**EXPERT COMMITTEE REPORT ON COLLAPSE OF
CANTILEVER PORTION OF COMMERCIAL BUILDING
AT SAMPIGE ROAD, MALLESWARAM,
BENGALURU**

2ND FEBRUARY 2017

**The Commissioner
Bruhat Bengaluru Mahanagara Palike
Bengaluru**

Ph. 35

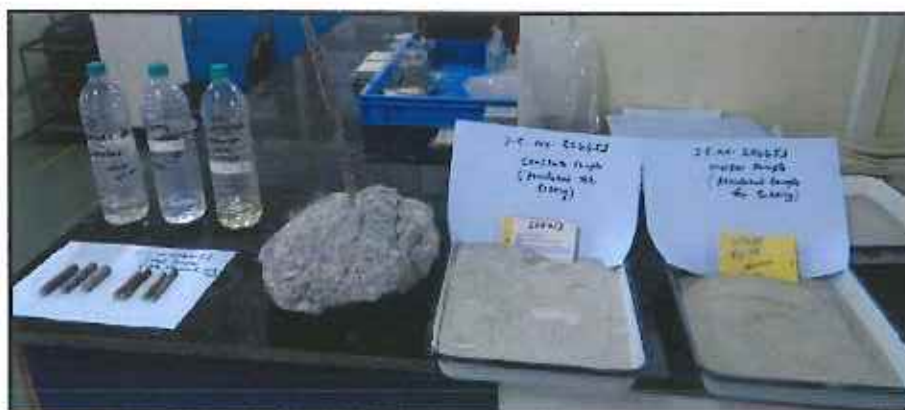
2. The screed concrete layer provided on the roof slab was 250-275mm thick with a density of 2098 kg/cum.
3. Cement content of concrete was found to be 200 kg/m^3 , which may be considered for mix design, if supplementary cementitious material like fly ash or GGBS is used in the mix. However, the required strength is not achieved, as seen from the core test results.

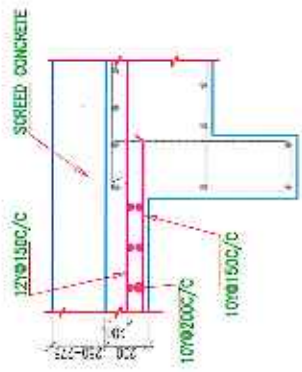
Point load at the tip due to r c parapet wall of height 1.3 m and 200 mm thick
 $0.2 \times 1.3 \times 2.5 = 6.5 \text{ kN}$

Unfactored bending moment = $10.25 \times 2^2/2 + 6.5 \times 2$
= 33.5 kN-m

Factored bending moment $= 33.5 \times 1.5 = 50.25 \text{ kNm}$

Moment of resistance of the section as exist at site = 19.9kN-m which is less than the Actual moment.

From the above, it is clear that the existing section is not capable of withstanding its own self weight along with the screed and parapet wall (without considering any live load on the roof)

FIGURE-1

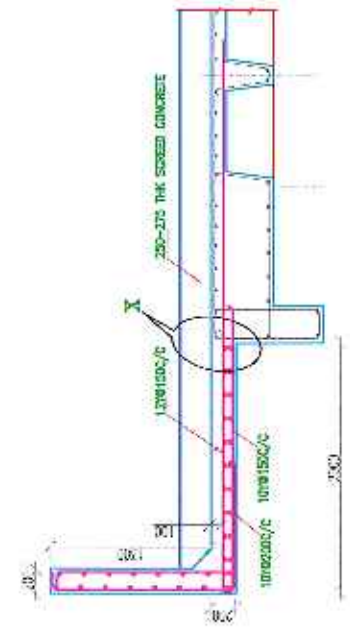
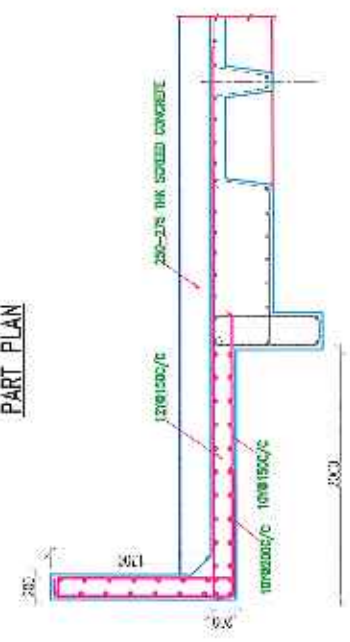
The structural drawings pertaining to the collapsed cantilever slab indicate the thickness of slab as 200mm and reinforcement of 12mm @150mm c/c at top and 10mm @150mm c/c at bottom. The concrete strength considered in the design is 25MPa, whereas the in-situ strength of concrete is 15 MPa. As observed at site, in the collapsed region, the top bars are provided at 100mm from top, reducing the effective depth to less than 100mm (Ref Annexure- III). The reinforcement diameter and spacing was found to be as per the drawing. Also, the screed concrete on top has contributed to the superimposed load by 5.25 kN/Sq.m , considering the thickness of 250mm (which appears to be more than the normally adopted

thickness). The calculations for the adequacy of the section, as provided at site, are appended in Annexure-III. The calculations clearly show that the cantilever section, as provided at site is structurally inadequate even for the dead load and superimposed load from the screed.

2. The failure of cantilever portion of roof slab is essentially due to the structural inadequacy of the section as provided at site. The disposition of top bars to the middle of the section, reduced in – situ concrete strength and increased superimposed load due to undue thickness of screed has made the cantilever section unsafe.

1. Since study on the collapse of the portion of the cantilever slab has shown that the slab is structurally unsafe, it is essential to support all the cantilever slabs at all levels through an appropriately designed supporting system to avoid recurrence of similar situation.
2. As the in situ strength of concrete in the tested region of the roof has shown lesser strength than the design requirements and loading on the roof is increased due to screed and other equipment, it is essential to verify the structural adequacy of the entire roof.
3. The cantilever portion in the scary room area shall be suitably supported to withstand the loading due to 5.5 m high peripheral wall. Alternatively, the wall can be replaced with 75mm thick rc wall, if the cantilever section provided can permit the same.

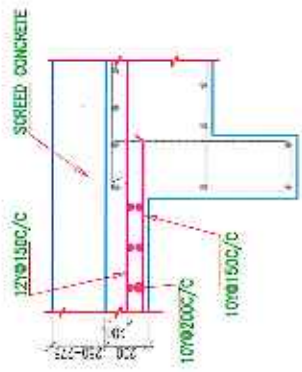
Point load at the tip due to r c parapet wall of height 1.3 m and 200 mm thick

Unfactored bending moment = $10.25 \times 2^2/2 + 6.5 \times 2$

= 33.5 kN-m

FIGURE-1

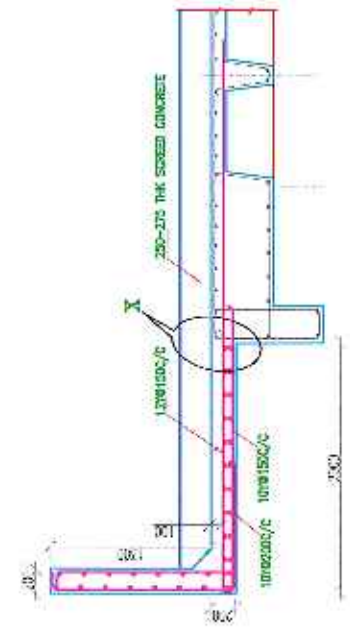
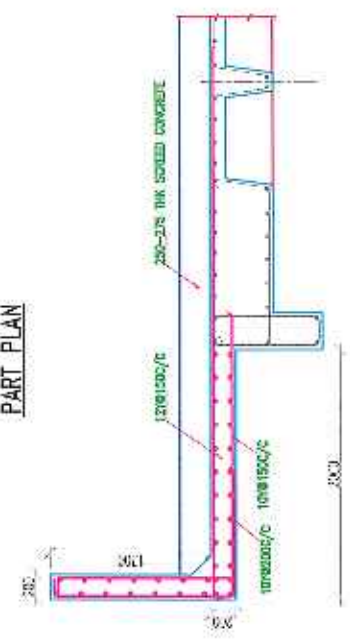
The structural drawings pertaining to the collapsed cantilever slab indicate the thickness of slab as 200mm and reinforcement of 12mm @150mm c/c at top and 10mm @150mm c/c at bottom. The concrete strength considered in the design is 25MPa, whereas the in-situ strength of concrete is 15 MPa. As observed at site, in the collapsed region, the top bars are provided at 100mm from top, reducing the effective depth to less than 100mm (Ref Annexure- III). The reinforcement diameter and spacing was found to be as per the drawing. Also, the screed concrete on top has contributed to the superimposed load by 5.25 kN/Sq.m , considering the thickness of 250mm (which appears to be more than the normally adopted

thickness). The calculations for the adequacy of the section, as provided at site, are appended in Annexure-III. The calculations clearly show that the cantilever section, as provided at site is structurally inadequate even for the dead load and superimposed load from the screed.

1. Since study on the collapse of the portion of the cantilever slab has shown that the slab is structurally unsafe, it is essential to support all the cantilever slabs at all levels through an appropriately designed supporting system to avoid recurrence of similar situation.
2. As the in situ strength of concrete in the tested region of the roof has shown lesser strength than the design requirements and loading on the roof is increased due to screed and other equipment, it is essential to verify the structural adequacy of the entire roof.
3. The cantilever portion in the scary room area shall be suitably supported to withstand the loading due to 5.5 m high peripheral wall. Alternatively, the wall can be replaced with 75mm thick rc wall, if the cantilever section provided can permit the same.
